DH Dufresne-Henry	PROJECT NAME: COLCHESTER PARK-AND-RIDE	
	PROJECT NUMBER: CMG PARK(15)S	
	FILE NAME: LA02.PTF	PLOT DATE: 07/09/02
	PROJECT LEADER: WLD	DRAWN BY: CGG
	DESIGNED BY: CSP	CHECKED BY: GAE
	RTE. 7 LAYOUT & EROSION LA02	SHEET (12) OF 56

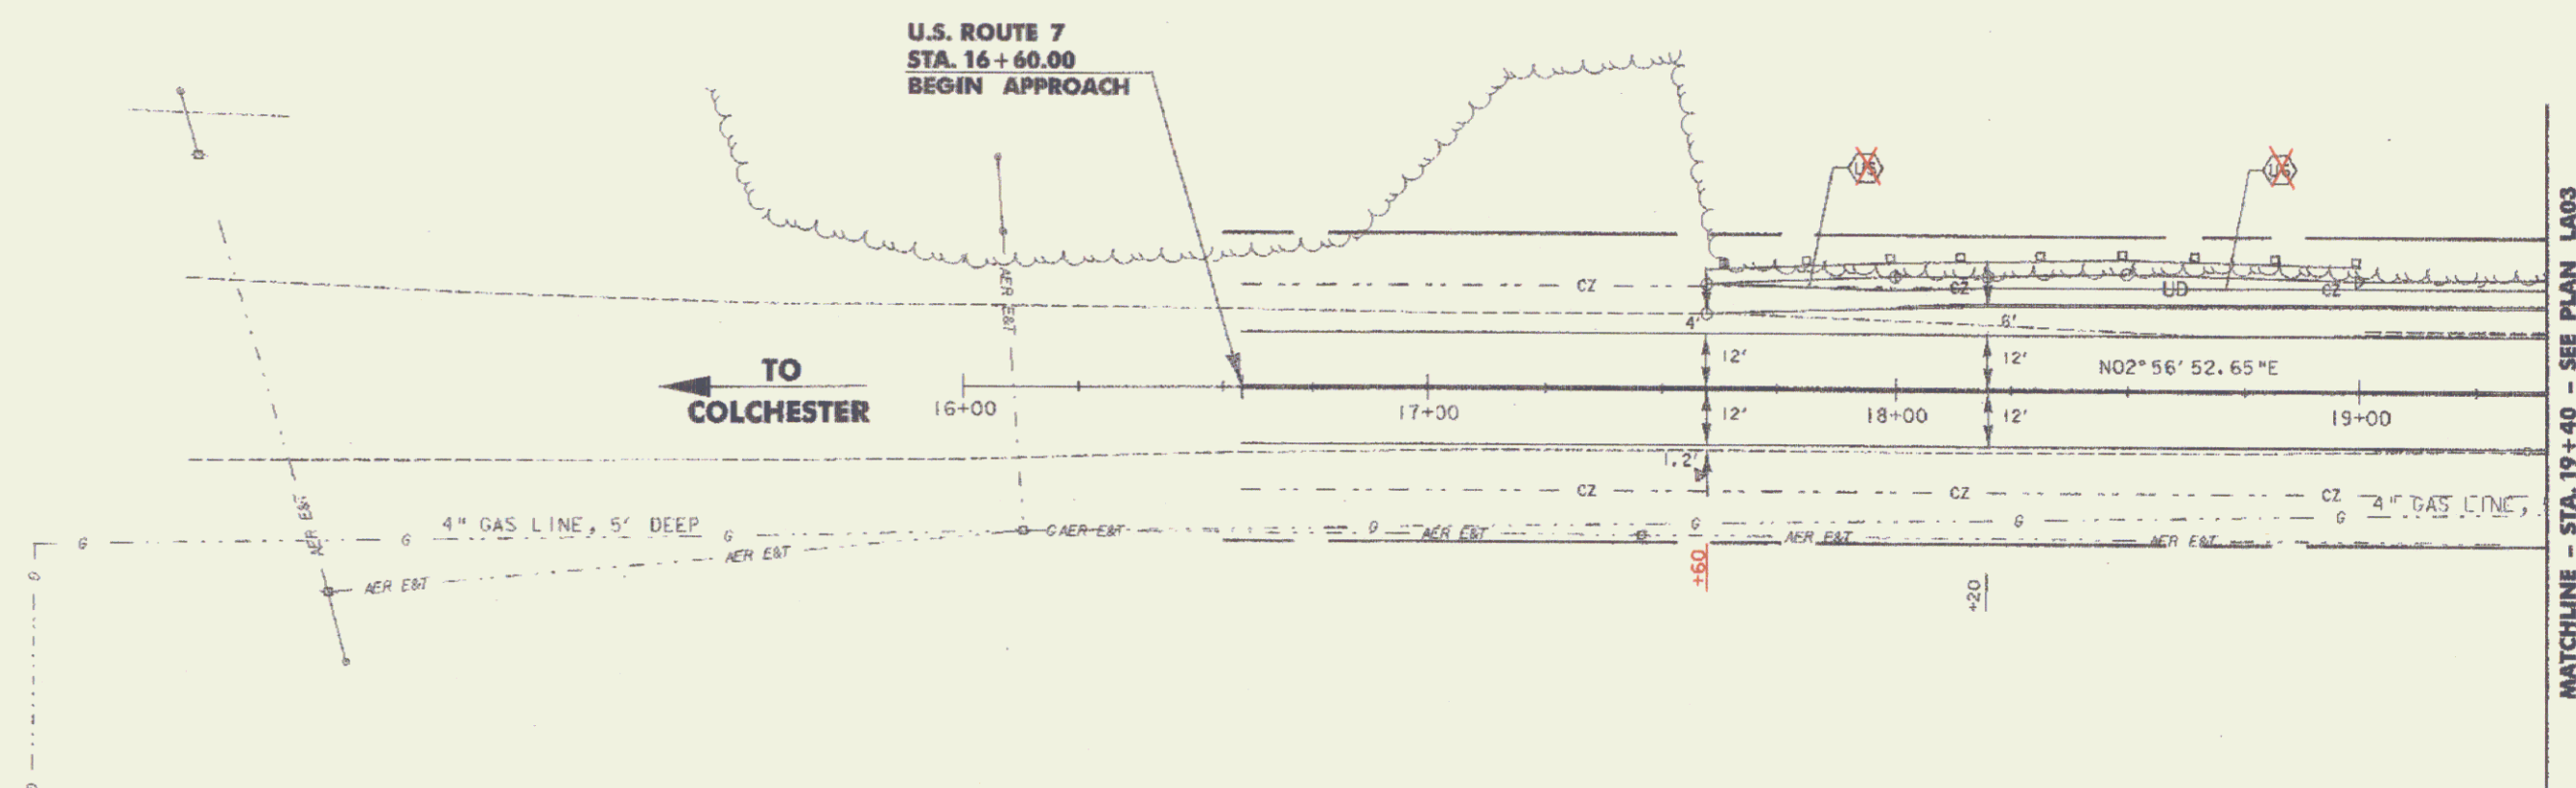
~~(15) U.S. ROUTE 7 STA. 17+60 TO 18+00, LT.
 NEW 6" X 40" UNDERDRAIN CARRIER PIPE,
 INV. IN = 223.02, INV. OUT = 222.75~~
~~(16) U.S. ROUTE 7 STA. 18+00 TO 19+40, LT.
 NEW 6" X 40" UNDERDRAIN,
 INV. IN = 222.75, INV. OUT AT STA. 22+50 = 216.28~~
